ZONING BOARD OF ADJUSTMENT, PANEL B  
WEDNESDAY, SEPTEMBER 18, 2013  
AGENDA

<b>BDA 123-090</b>	2614 Boll Street <b>REQUEST:</b> Application of Elias Rodriguez for a special exception to the landscape regulations	1
<b>BDA 123-093</b>	6932 Tayloe Street <b>REQUEST:</b> Application of Ignacio P. Garcia for a special exception to the front yard setback regulations for a carport	2

<b>BDA 123-081</b>	2912 Maple Avenue <b>REQUEST:</b> Application of Karl A. Crawley for a variance to the off-street parking regulations and a special exception to the landscape regulations	3
--------------------	--	---

<b>BDA 123-082</b>	5629 SMU Boulevard <b>REQUEST:</b> Application of Carlos D. Goyne, Café Build, LLC for a special exception to the off-street parking regulations	4
<b>BDA 123-089</b>	5506 Miller Avenue <b>REQUEST:</b> Application of Alfonso Solis, Jr. to appeal the decision of the administrative official	5

LANDSCAPE PLAN  
 2614 BOLL ST

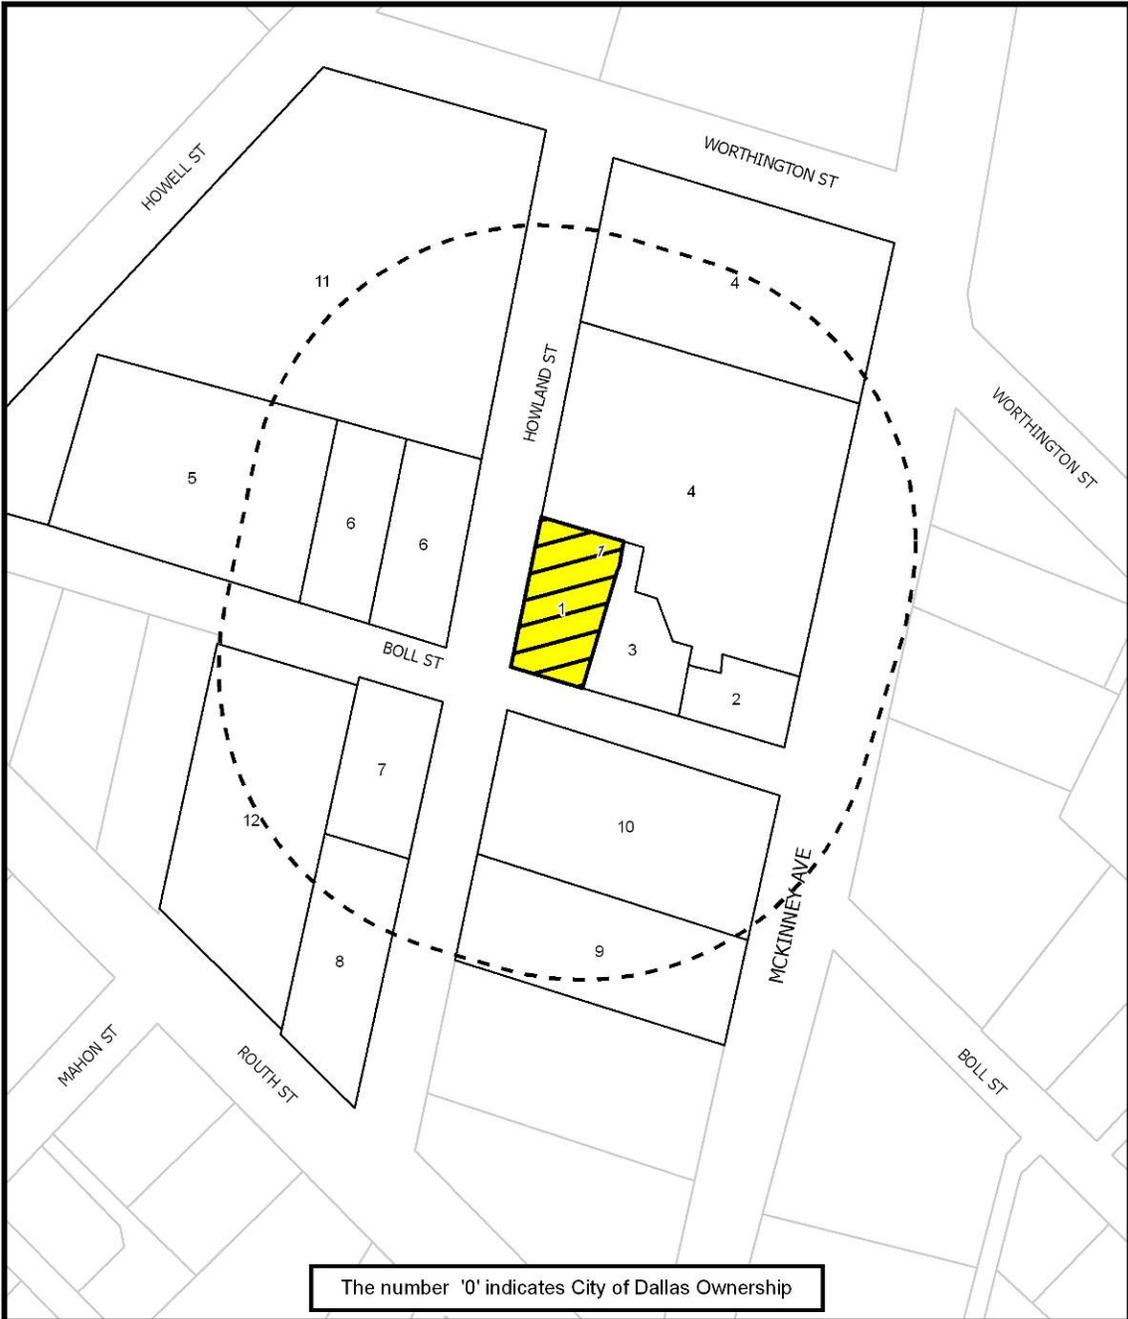
The proposed plan is deficient of PD 193, Part 1 requirements for sidewalk size and placement and tree planting zone requirements.

The tree planting zone is required to have one tree for every 25 feet of frontage, excluding the driveway and visibility zone. The site should have a minimum of 5 street trees planted between 2.5' - 5' from back of curb. The proposal would have no new trees planted within the designated tree planting zone.

Significant large trees are to be maintained on the property with the intent of fewer site changes to minimize damage to the mature tree root systems. The owner proposes to allow for manual irrigation of plant materials to reduce risk with installation of trenching for new irrigation lines. A significant large mature catalpa tree in the front of the structure is sensitive to potential critical damage to tree root systems. The mature trees along the Howland Street side are relatively close to the street and will be susceptible to root damage with the installation of the required sidewalk. Placing the sidewalk closer to the curb reduces the risk to these trees.

I recommend approval of the proposed alternate landscape plan because the owner has demonstrated the plan does not compromise the spirit and intent of the PD 193 landscape requirements.

BDA 123-081  
 (A) SITE PLAN- 2912 MAPLE AVE.  
 1" = 10'-0"  
 ZONING- LC

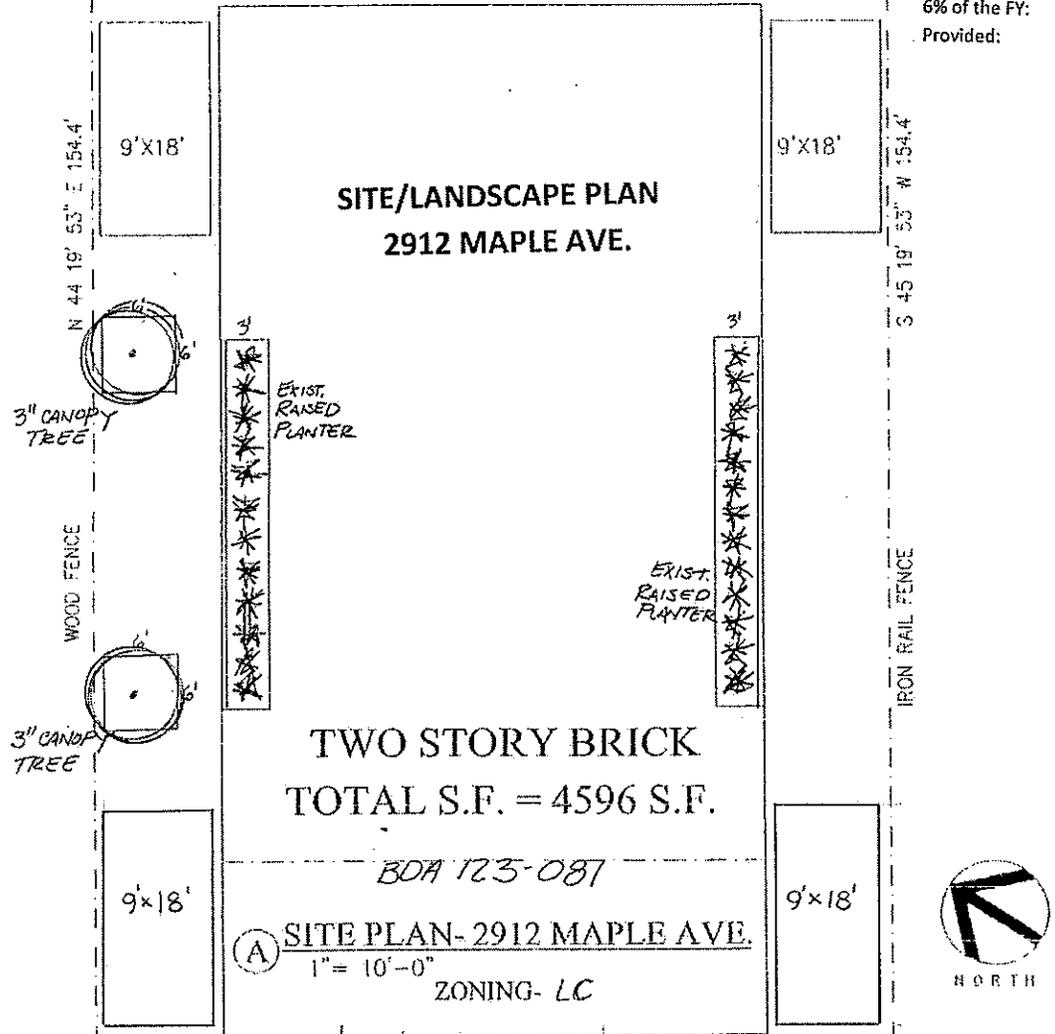
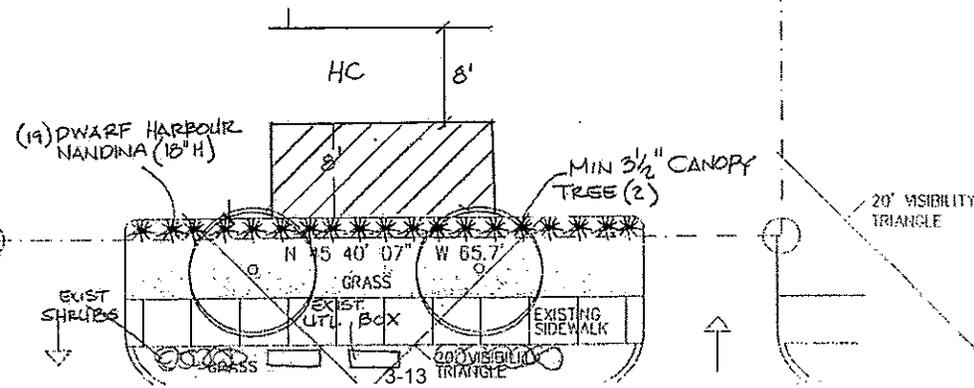
193.126(b)(1)(A), Designated landscape areas. The plan provides less than 10% of lot and less than 60% FY. There is insufficient FY general planting and special planting.

193.126(b)(3), Off-street parking and screening requirements. The plan provides less than 42" tall screening material. The maximum potential growing height for the proposed "dwarf harbor nandina" is 3 feet.

193.126(b)(5), Trees. The plan provides two 3.5" large canopy trees outside of the tree planting zone but within the parkway. The district requires one tree per 25' of street frontage to be planted within the space 2.5 - 5' from back of curb. In this case, the parkway tree planting zone is congested with utility infrastructure above and below ground. The trees are identified on the plan to be within the parkway but not

There is adequate space within the front yard of the property, on either side of the handicapped loading zone, to prepare protected allowable space for planting one or more trees in the property front yard and spaced further away from overhead utility lines.

I recommend denial of the request for the special exception because, in my opinion, the owner has not demonstrated "the special exception will not compromise the spirit and intent of this section."

BDA 123-081  
**SITE PLAN- 2912 MAPLE AVE.**  
 1" = 10'-0"  
 ZONING- LC

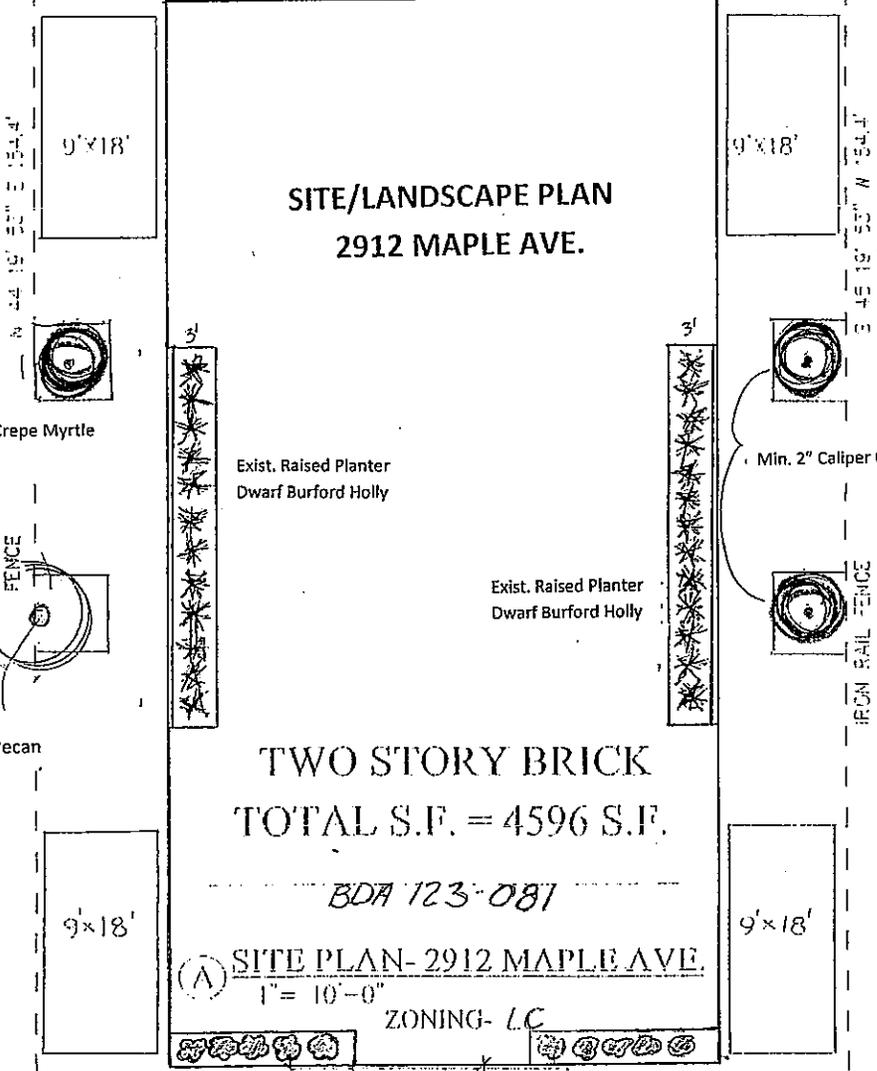
- The arborist’s September memo lists the following ways in which the applicant’s alternate revised landscape plan is deficient to the PD 193 Landscaping Requirements:

1. Designated landscape areas: The plan provides less than 10 percent of lot and less than 60 percent front yard with insufficient front yard general planting and special planting.

2. Off-street parking and screening: The plan provides less than 42” tall screening material-the maximum potential growing height for the proposed “dwarf harbor nandina” is 3 feet.

- The arborist’s September memo lists the following factors for consideration:
    1. Trees: The amended landscape plan now provides two, 3.5” large canopy trees within the required front yard.

1. Compliance with the revised alternate landscape plan submitted at the August 21<sup>st</sup> public hearing is required.
2. If an existing pecan tree is removed, it must be replaced with another tree of similar species under the size specifications in 51P-193.126(b)(9), General Maintenance. In addition, the tree removal must be fully mitigated per Article X of the Dallas Development Code.
